J. A. JONES CONSTRUCTION COMPANY

Contract No. W3-NY-4

POP-N-713
USE OF DISCREPANCY REPORTS

| PROJECT TITLE: WATERFORD SES UNIT #3, PHASE I CONCRETE CONSTRUCTION | | Rev. No. & Date: Rev. 3 | |

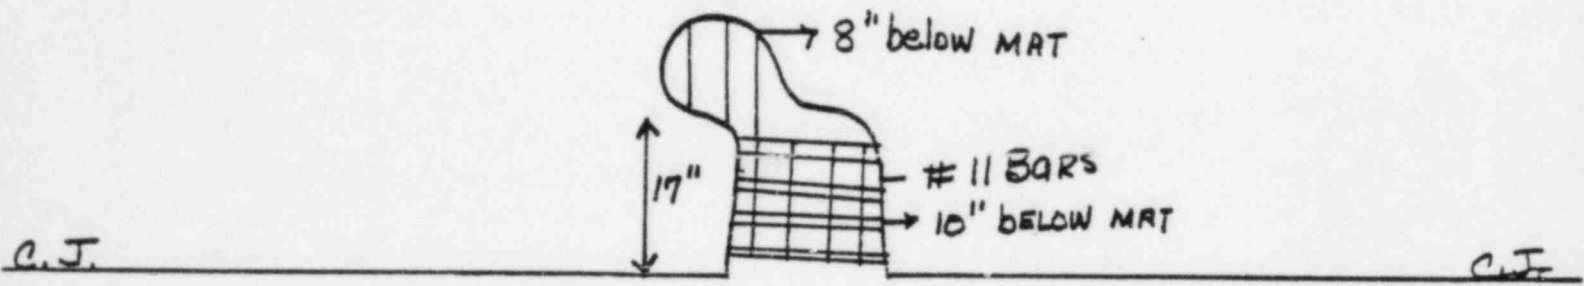
An area 3'6" high x 4'0" long x 11" deep along middle of Keyway is void of sound concrete. This possible loss of shear area exists on the west wall of pour G-499503-19.

~~Not 100% Accurate From Top of Bottom Re-bar To Bottom of Top Re-bar~~
IN THE ABOVE AREA RECOMMENDED DISPOSITION IS ACCEPTABLE

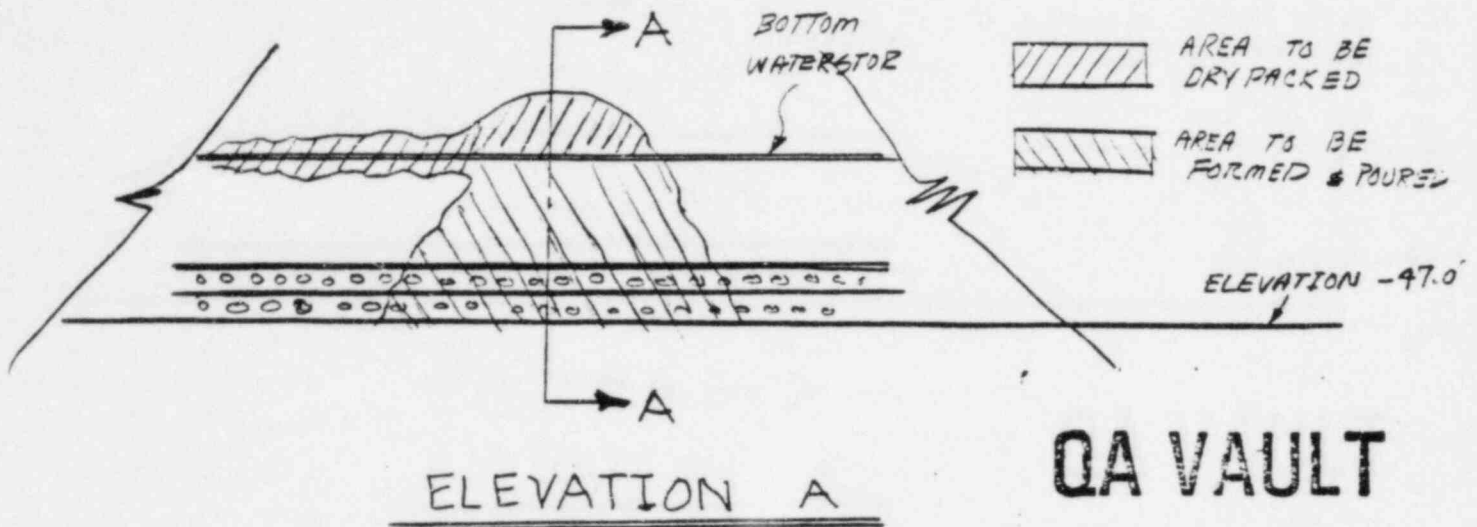
Remarks: Finished Pour at 12:15 PM 5/20/76 R.W. Lewis area Dry

Packed 5/20/76, cure start. Area will be cured with concrete placement 18

EAST FACE PLACEMENT NO. 16

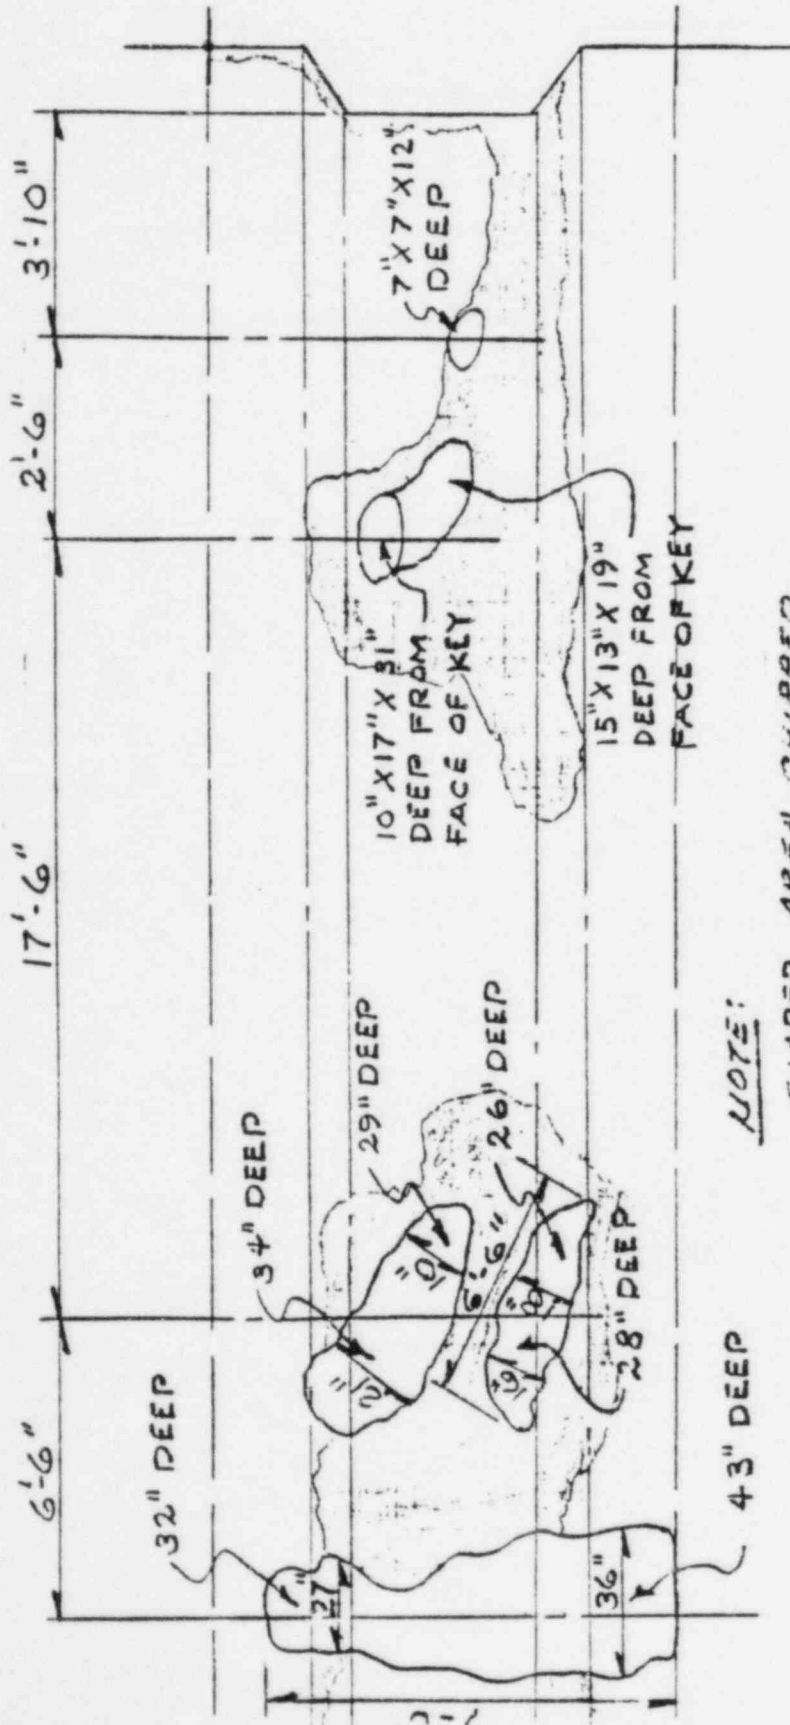
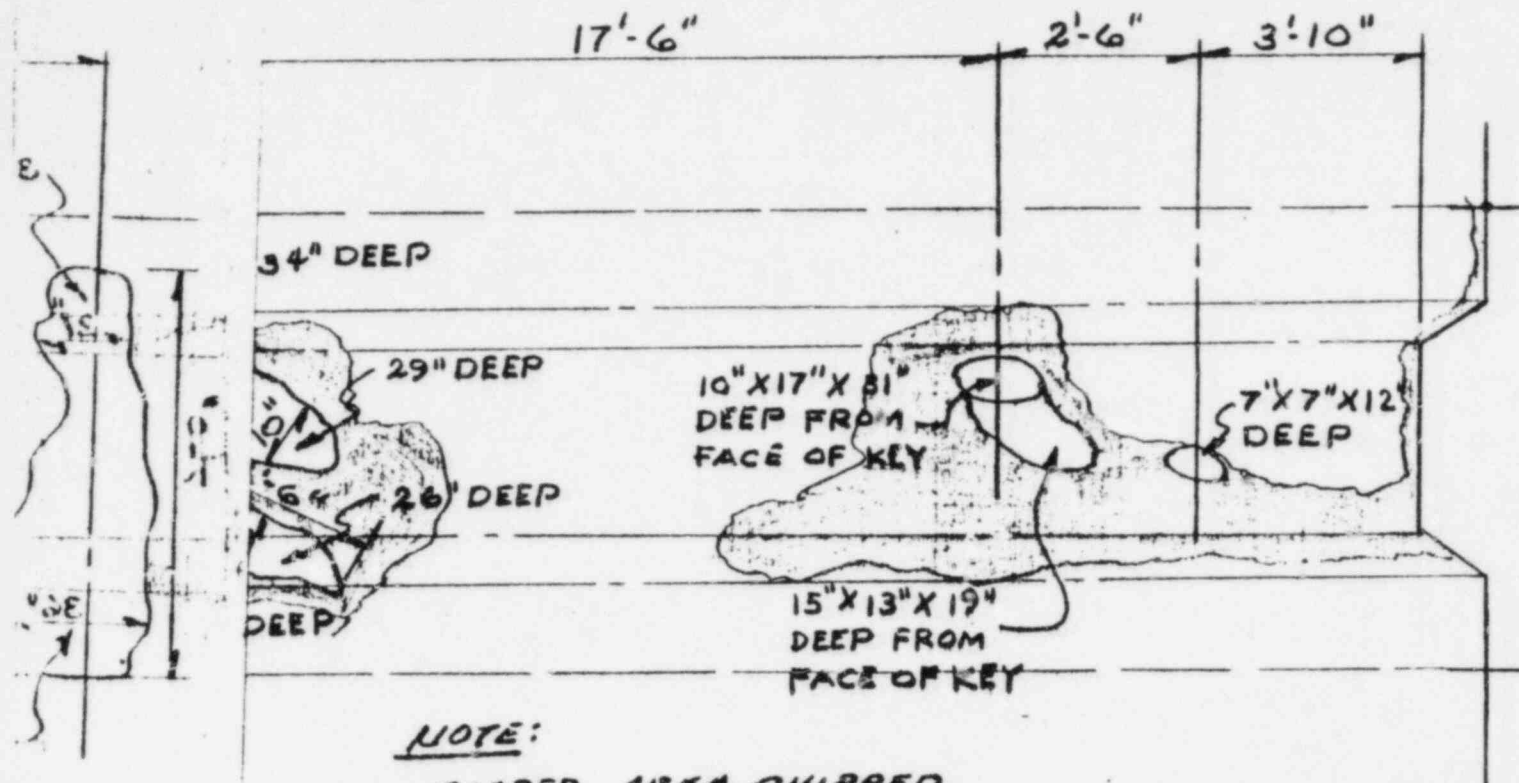
SHADED AREA CHIPPED
FROM 2" TO 4" DEEP
